**REVIEWED FOR
CODE COMPLIANCE**
BP-17-3412-CADD
501 SE 2ND ST
BLDG B

BLS - TRANSPORTATION FACILITY 2017
501 SE 2ND STREET BEND, OR
**FLOOR PLAN - PLUMBING
SHOP BUILDING**

SHEET NO.
P1.25

1 FLOOR PLAN - PLUMBING

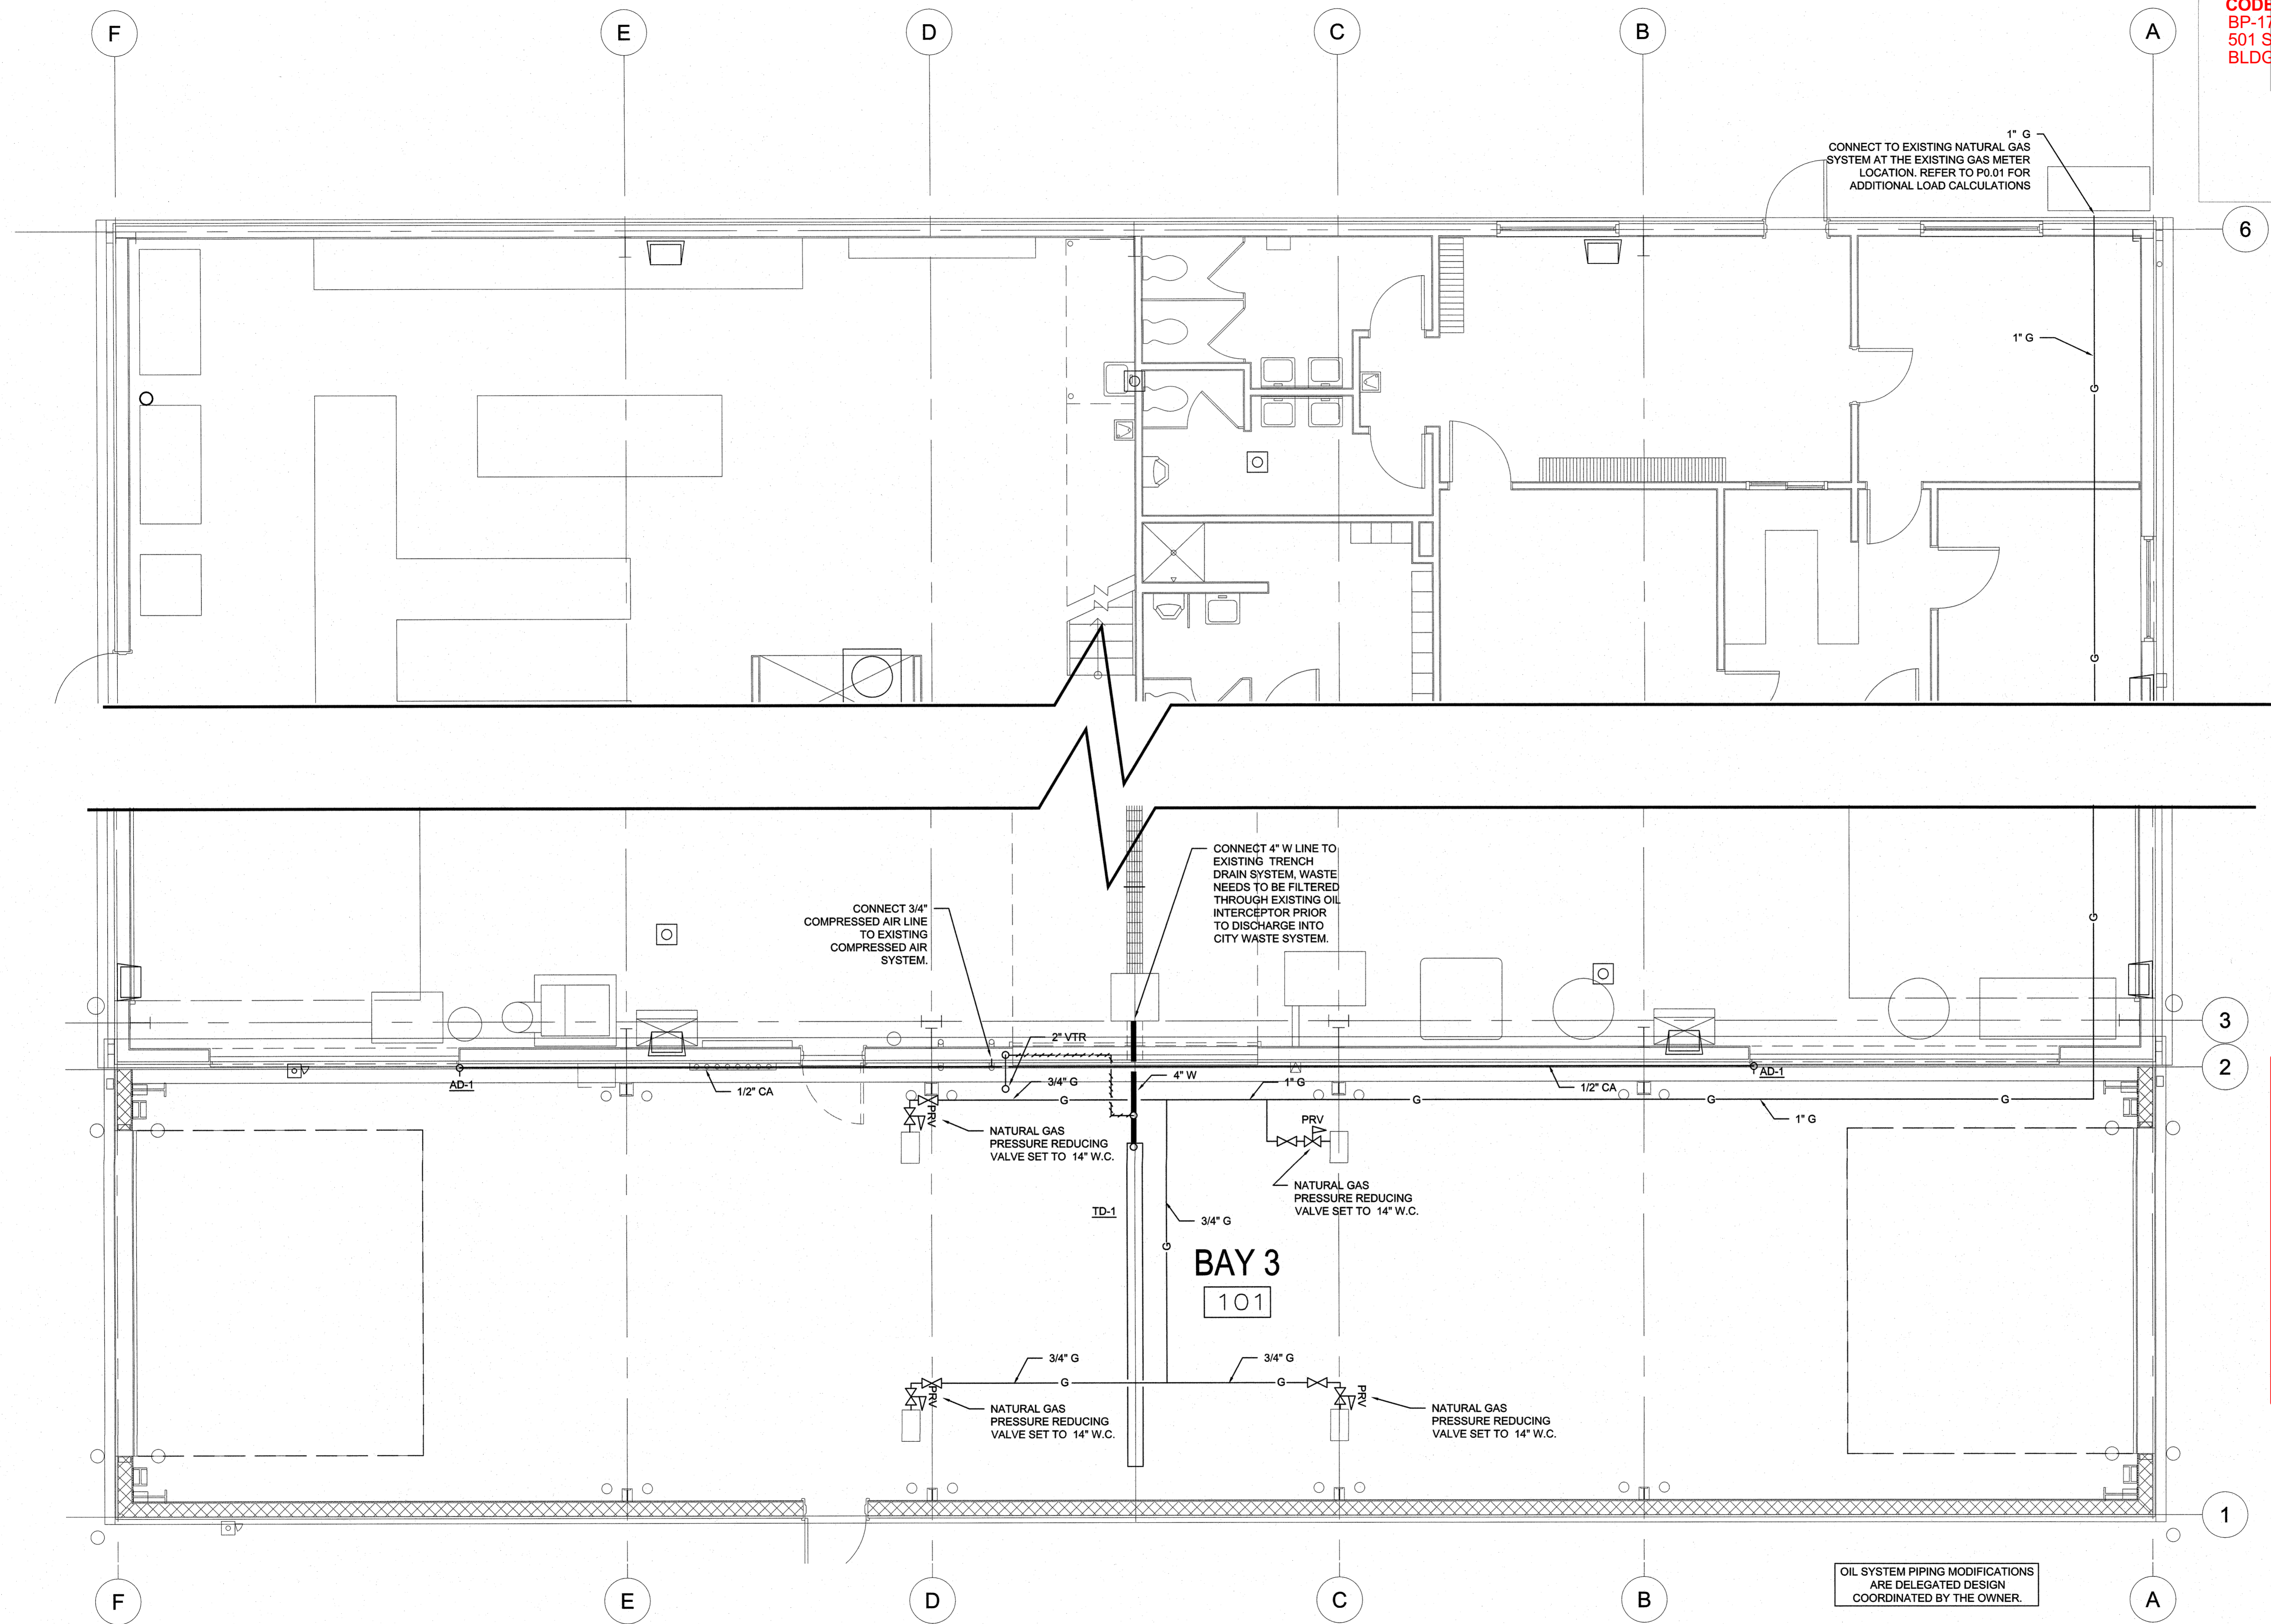
All plumbing systems,
piping, installation
and fixtures shall
comply with the 2014
OPSC.
Provide trap and vent
for trench drain per
OPSC 1001 and
1001.3.
Provide trap seal
protection for trench
drain per OPSC
1007.1. JMI 07/19/17
